Palaterra Subdivision Addition 2
Summary of Community Meeting
March 4, 2021

Subject: Proposed Palaterra Subdivision Addition 2 plat, with variance for intersection distance

**A Preliminary Plat of:
Lots 1-12,
Palaterra Subdivision
Addition 2, with Variance**

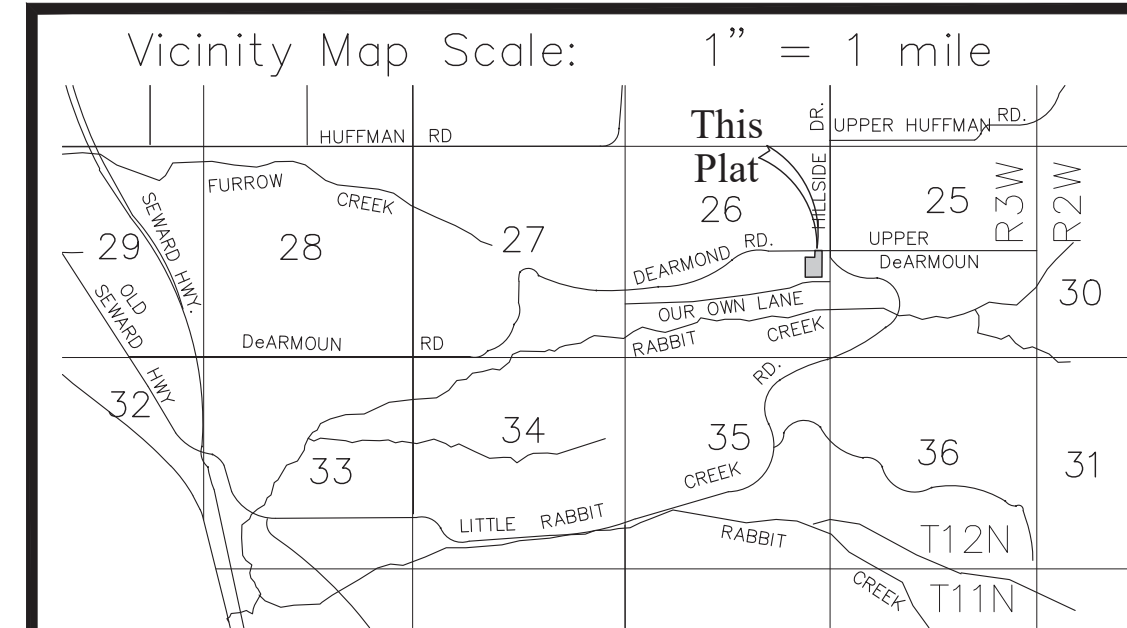
Q: (In regards to the cul-de-sac intersection with De Armoun, from the current resident of Collier Subdivision Lot 1) Why does the road directly abut the Collier Subdivision Lot1 lot line? Can it be moved farther away from said property?

Q: Will you be removing vegetation from the southern slope of Lot 5, 6, & 7? I have concerns about erosion and flooding.

Q: On previous plats notes have been added that no soil movement or modification to drainage patterns could occur that would impact nearby rights-of-way or neighboring property. I do not see such a note on this plat and would like one to be added.

Q: What is the drainage plan for the road/access?

Q: Will there be enough room for snow along the cul-de-sac access?

A: The cul-de-sac access ROW is placed in such a way because there is an existing house on proposed lot 12. Said house also has a septic system, which the ROW has to be 10 feet away from the nearest standpipe. Both of these factors affect the access position.

A: There are no plans to clear or develop the southern slope of the project location. Lots 5, 6, & 7 are very large to allow ample room to develop at the northern ends of the proposed lots.

A: The plat notes you are seeing are notes laid out and required by the planning department. They will tell us what notes need to be added to the plat. I will record your request for our submission though.

A: A drainage plan will be done prior to the plat recording, and requirements will have to be met so as to not negatively affect any neighbouring properties.

A: This will be a dedicated ROW with a paved road, allowing ample room for snow.
